A revised proposal for Supplement 5 to Regulation No. 28

The text reproduced is based on ECE/TRANS/WP.29/GRB/2016/4 and shows the modifications agreed at the GRB session on 5 September 2016. These modifications are highlighted in yellow.

"Uniform provisions concerning the approval of audible warning devices and of motor vehicles with regard to their audible warning signals

Figure 1

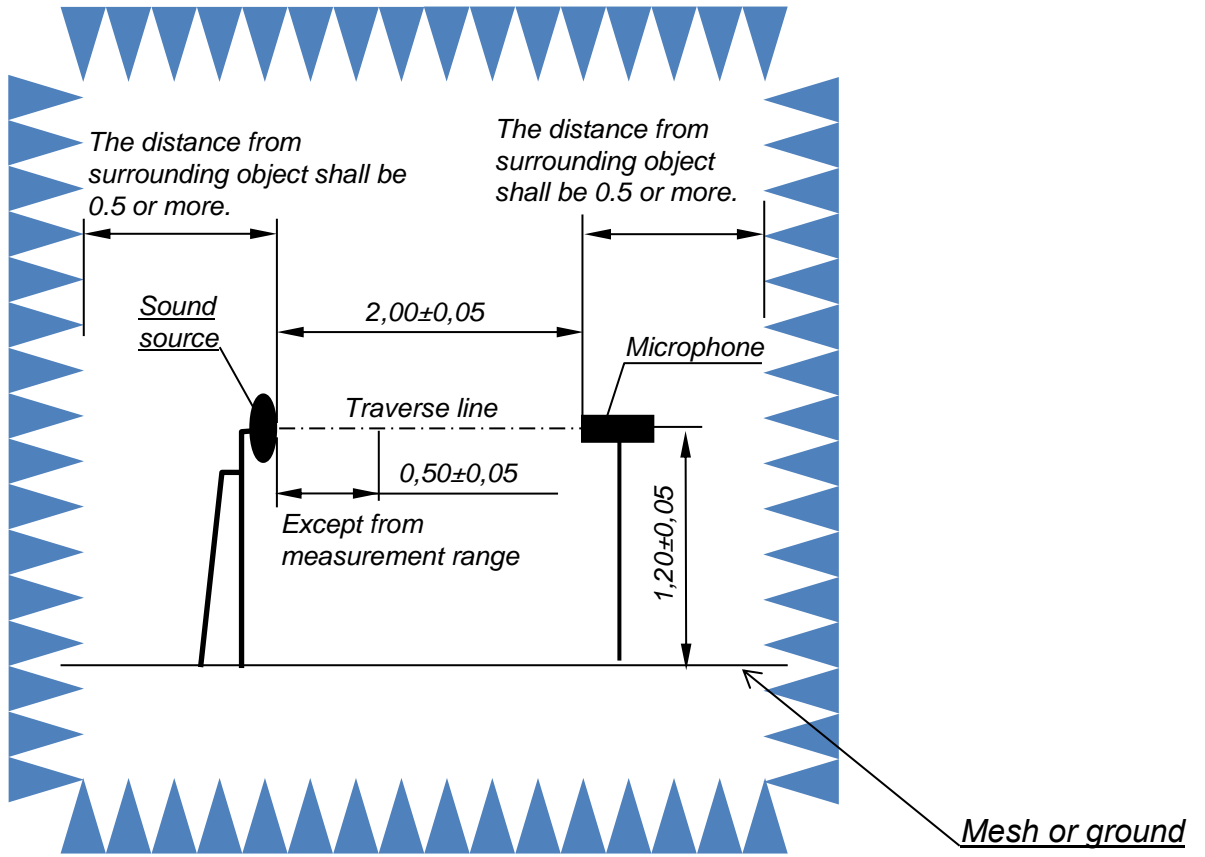
- A minimum of 10 points shall be used for evaluation on the microphone traverse line. The measurement shall start at 0.5 ± 0.05 m from the sound source, and spacing shall be 0.15 m (e.g. Figure 1);

Microphone positions for measurements of acoustics parameters of audible warning device, audible warning system, multiple audible warning system

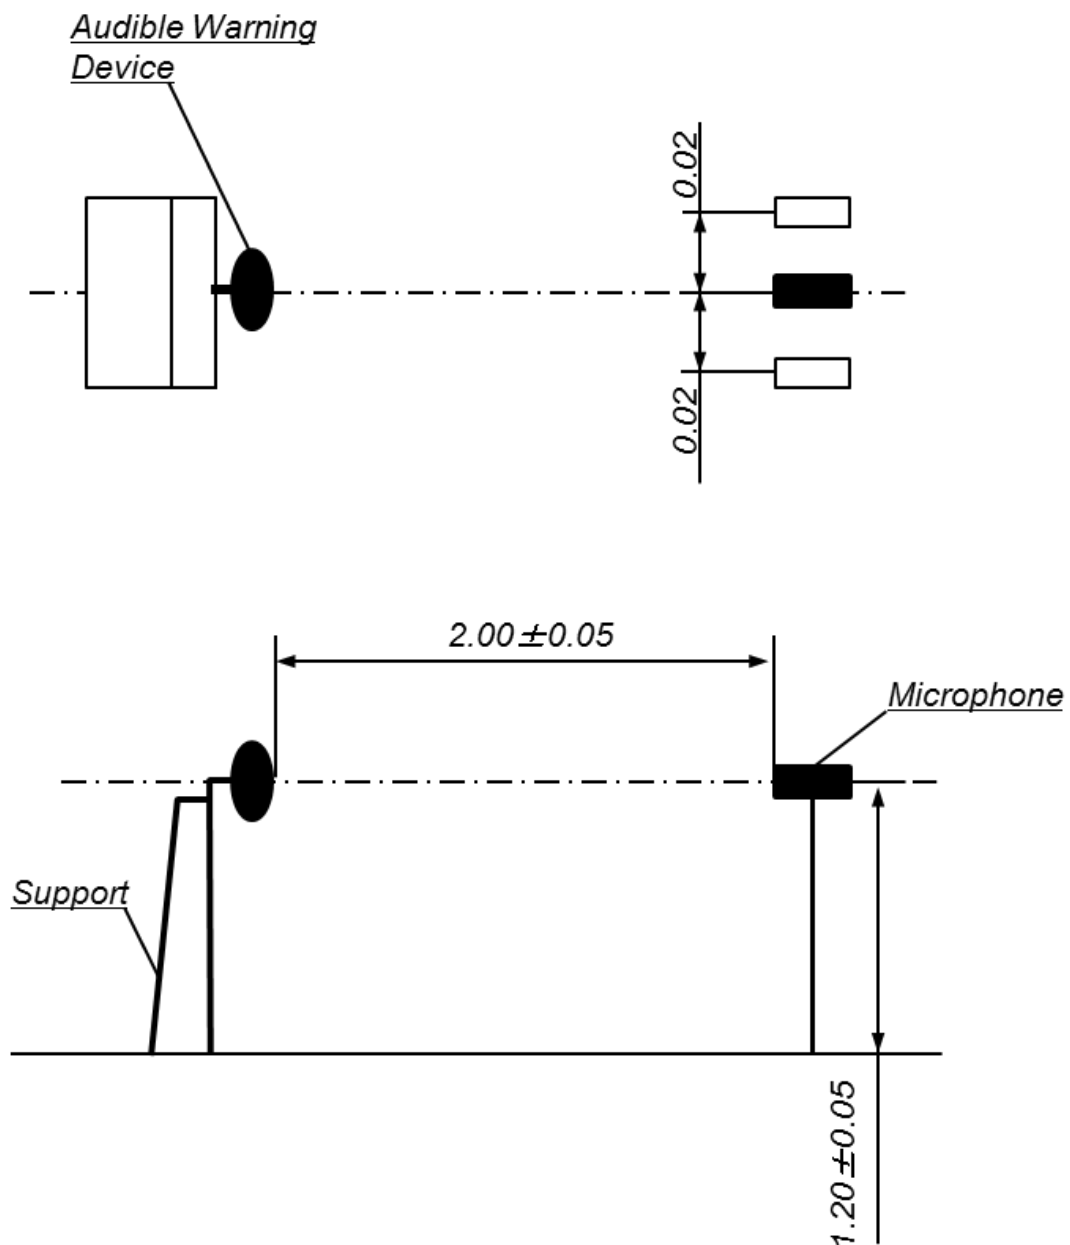
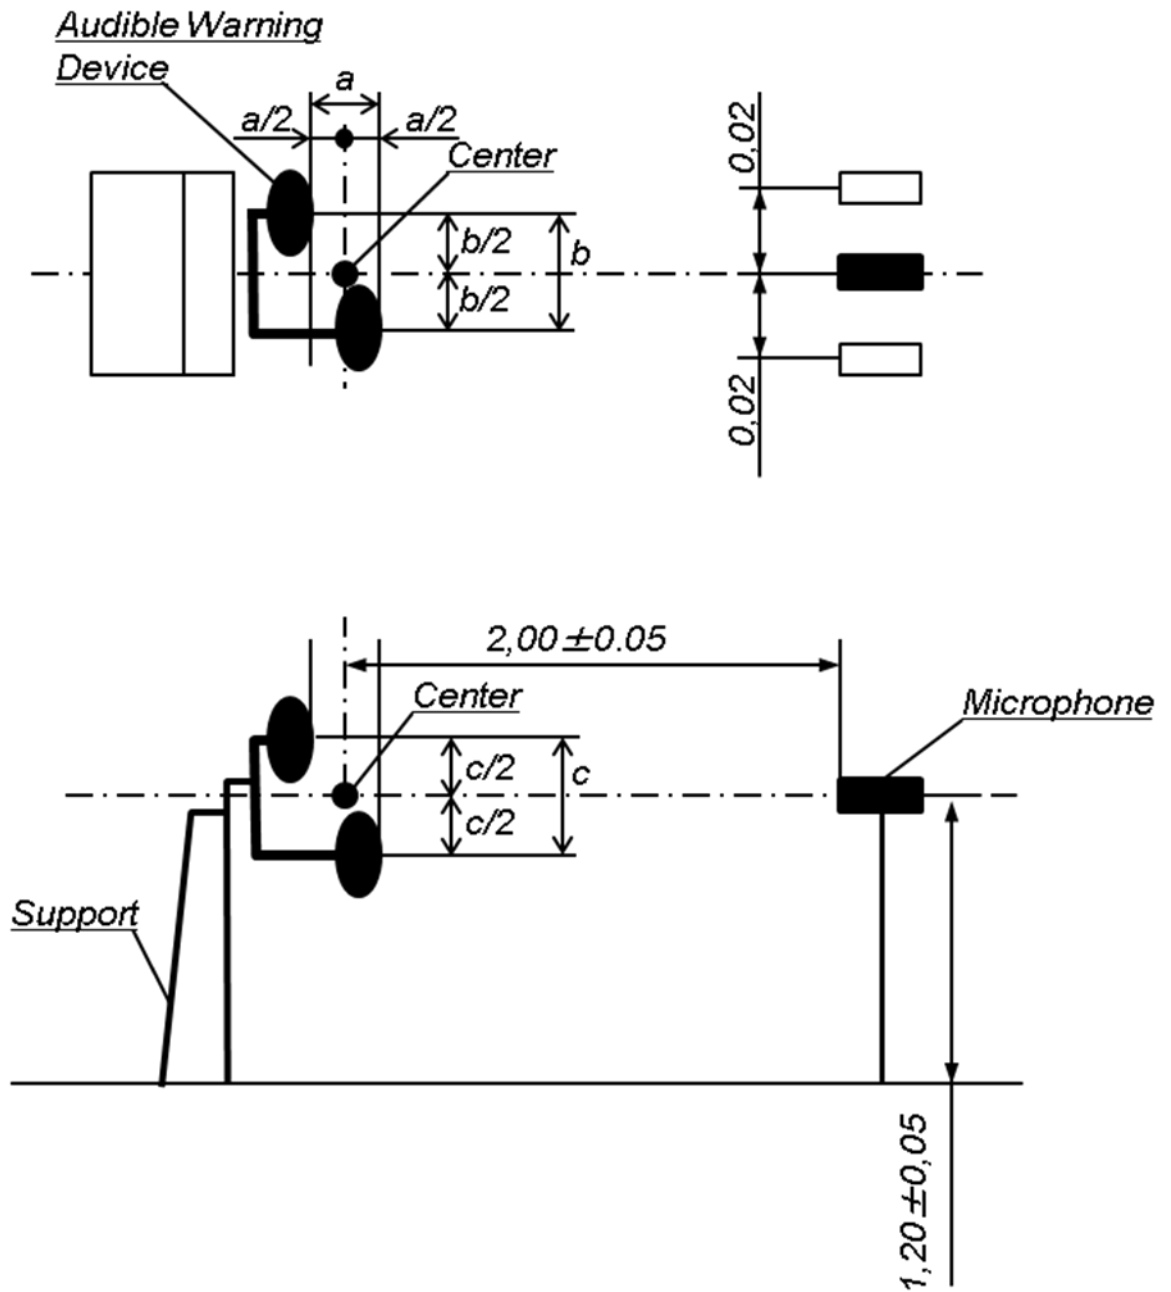
The microphone shall be so placed that its diaphragm is at a distance of 2.00 ± 0.04 0.05 m from the plane of the sound outlet of the audible warning device, audible warning system, multiple audible warning system. The microphone must be positioned facing the front surface emitting sound of the audible warning device, audible warning system, multiple audible warning system in the direction in which the maximum sound level can be measured. See figure in Annex 4.

13. The text provides for clarification on the positioning of the measuring microphone during the tests. The reference to the Annex 4 is added.

Microphone positions for measurements of audible warning signals of motor vehicles

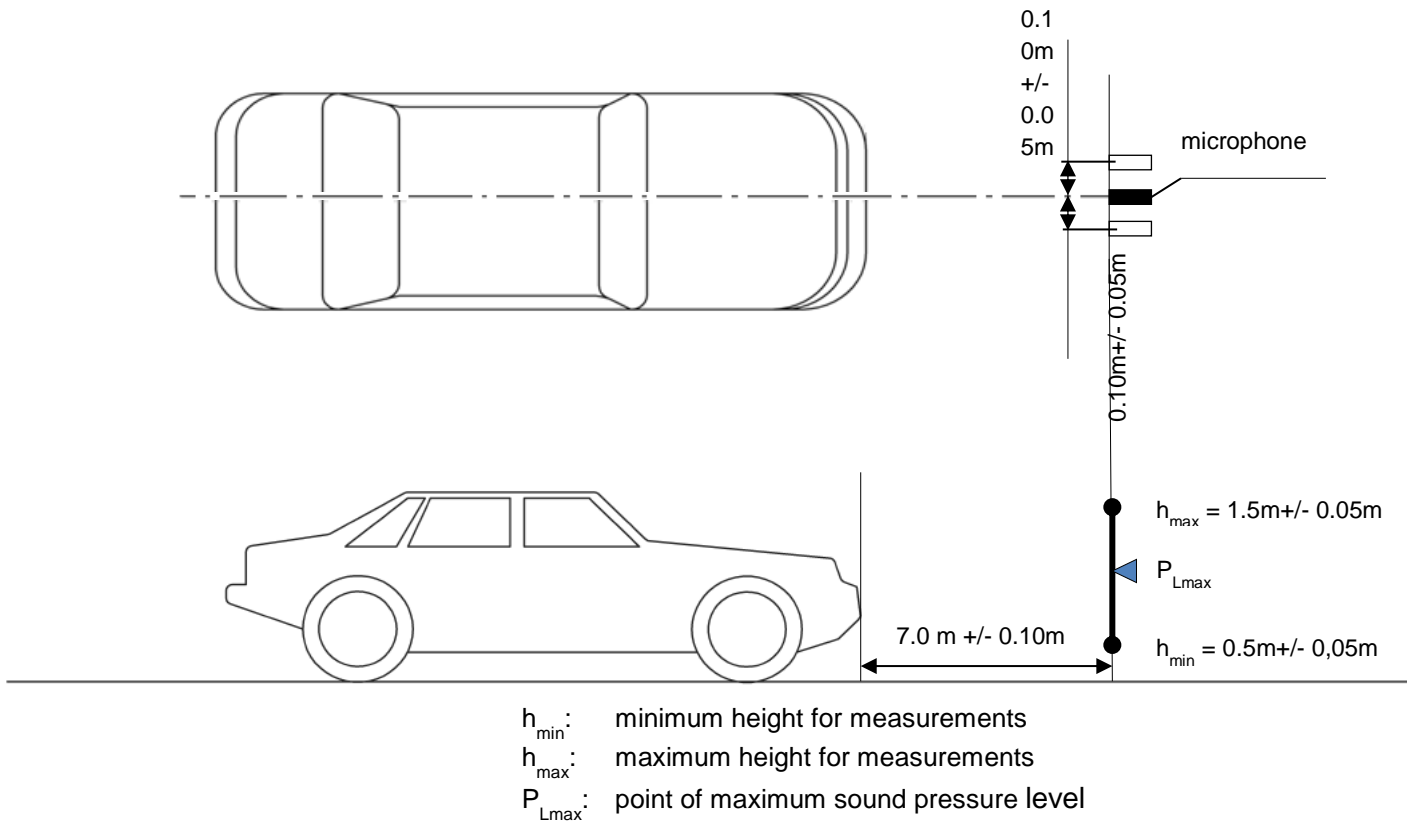
1. Sections 7, 10, 15, 19 reflect the change of headers. A new section 18 is added. A new Annex 3 is added with qualification criteria for anechoic space. New Annexes 4 and 5 are added with graphical information.
